European Union Aviation Safety Agency
Notice of Proposed Amendment 2020-01

Regular update of CS-25

RMT.0673

Figure 1. Trajectory Assessment for OEI Go-around

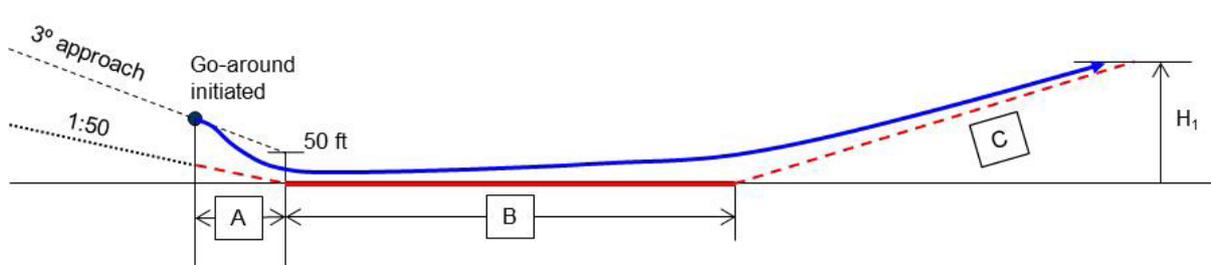
It is proposed to amend AMC 25.101(g) to provide guidance with respect to acceptable go-around flight profiles, as follows:

The go-around demonstration specified in Chapter 1 of this AMC can be conducted at an altitude above the normal decision height/altitude (for test safety), with the height loss in the manoeuvre used to show that ground contact prior to the runway threshold would not occur if the manoeuvre was initiated at the decision height/altitude. Flight testing, simulation and/or analysis at a range of (WAT limit or simulated WAT limit) conditions throughout the approved envelope should be conducted to assess the height loss relative to the decision height/altitude consistent with the criteria for the weather minima to be approved (or higher as constrained by AFM limitations). At least one flight test or pilot-in-the-loop simulator test should be conducted at a WAT-limited condition to assess the OEI go-around procedure and establish the time delays used for any subsequent analysis/simulation.

In addition, the assessment of the go-around procedure should include consideration of the horizontal distance (based upon the minimum go-around trajectory) needed to establish the minimum engine-out climb gradient required by CS 25.121(d) or a steeper gradient as required by specific weather minima operational criteria. It should be shown by flight test, simulation and/or analysis that the aeroplane would remain above the profile illustrated in Figure 1 below when the go-around is evaluated at the critical WAT limit condition (up to the structural maximal landing weight) and flown in accordance with the one-engine-inoperative (OEI) go-around procedure.

Segment A: From the initiation of go-around at the decision height/altitude to the runway threshold – remain above a 1:50 (2.0 %) plane extended to the runway threshold for clearance of airport obstacles.

Figure 1. Assessing the Combined Risk of All Non-Fault-Tolerant Failures

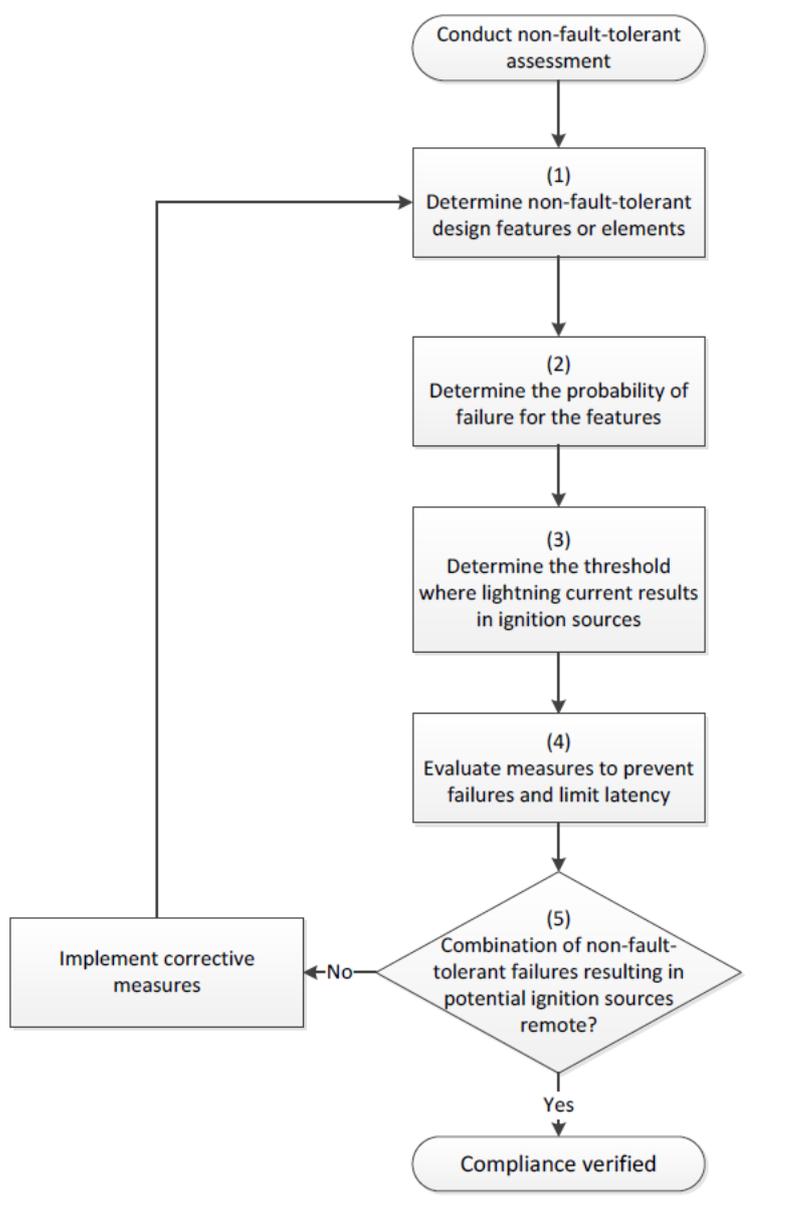
4.2.5.5 Figure 1 of this AMC provides a guide to the qualitative assessment process. Each of the activities in the qualitative assessment process, shown in Figure 1, is discussed in the paragraphs that follow.

4.2.5.6 Figure 1, Item (1).

The first step is to determine whether there are design features or elements that do not provide fault-tolerant lightning protection, as described in paragraph 2.9.4.3.

4.2.5.7 Figure 1, Item (2).

4.2.5.8 Figure 1, Item (3).

4.2.5.9 Figure 1, Item (4).

4.2.5.10 Figure 1, Item (5).
